Re: The Dehkordi Residence; 146 Robin Way,
Architecture and Site Application S-19-043

Below is an itemized response to the Town Consulting Architect's comments dated December 9, 2019.

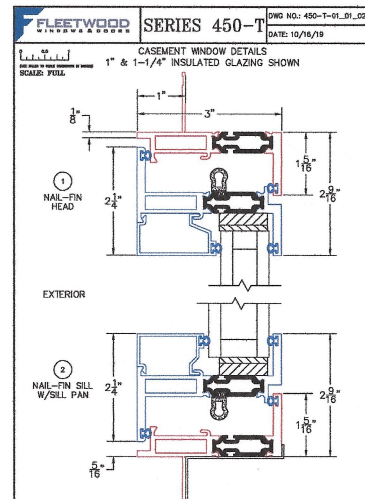
5. The windows proposed are of durable aluminum and of the highest quality and energy efficiency. It should also be known that a great majority of high end, new houses, modern or traditional in style, have these metal framed windows or have a wood frame with aluminum cladding on the exterior for their durability. Both look very similar to each other. This has long been a standard in the high end residential construction industry. The aluminum windows we propose will look virtually identical to wood framed, aluminum clad windows, but also have the same heft and detail of a wood framed window. For reference, please see the Fleetwood windows below.
